**CEDAR CREEK PARKWAY WEST 2024 IMPROVEMENTS
WAIVER FROM LAND DEVELOPMENT REQUEST 2024-703
ATTACHMENTS**

TO: PLANNING COMMISSION
FROM: GREGG ADAMS, PLANNER
SUBJECT: CEDAR CREEK PARKWAY WEST 2024 IMPROVEMENTS
WAIVER FROM LAND DEVELOPMENT REQUEST 2024-703
REQUEST FOR PLAN REVIEW

SUBJECT: South Whitehall Township
 Cedar Creek Parkway West
 2024 Improvements
 Waiver from Land Development
 Process Request #2024-703

RE: Geotechnical Engineering Review of
Provided Documents
Cedar Creek Parkway West
2024 Improvements
Waiver from Land Development 2024-703
South Whitehall Township, Lehigh County,
Pennsylvania
Hanover Project SWT24-11(009)

**PLAN
 CHANNEL RESTORATION AND COURT REMOVAL**

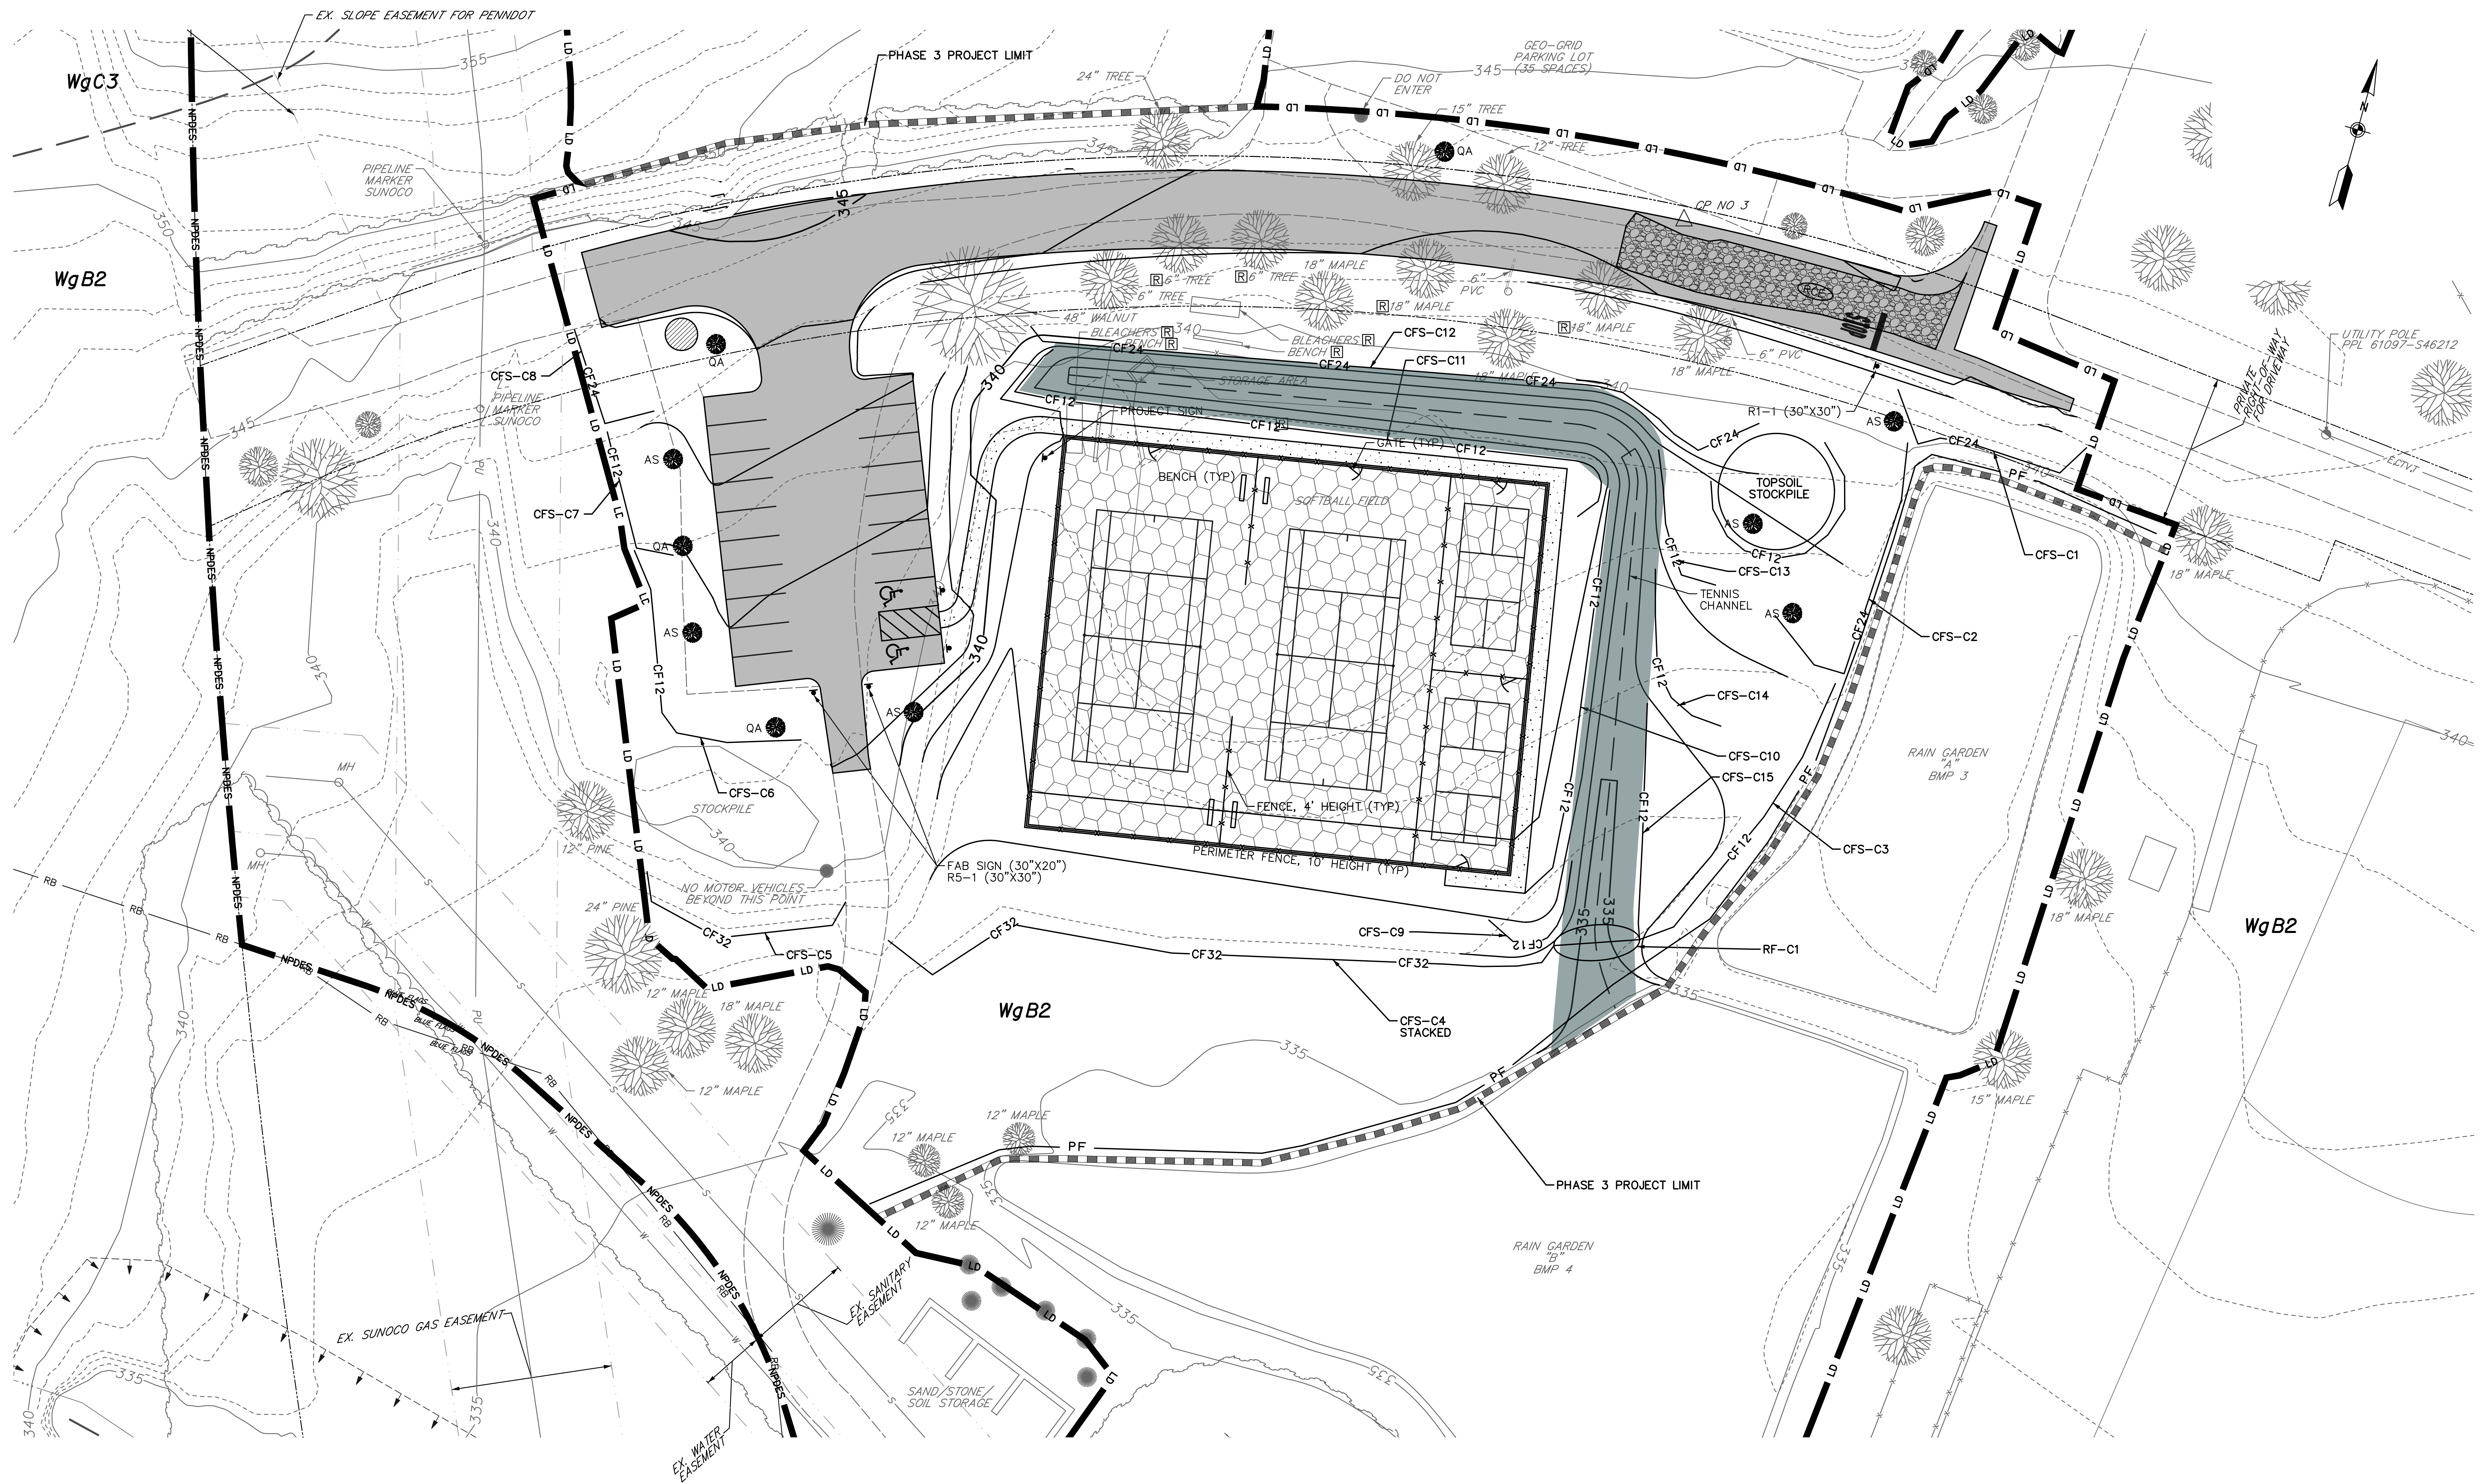
4. Provide appropriate design calculations (including a drainage patterns map – as applicable) for the proposed swale/channel(s) around the tennis/pickleball courts and for the channel restoration area, SALDO §312-12(b)(38);
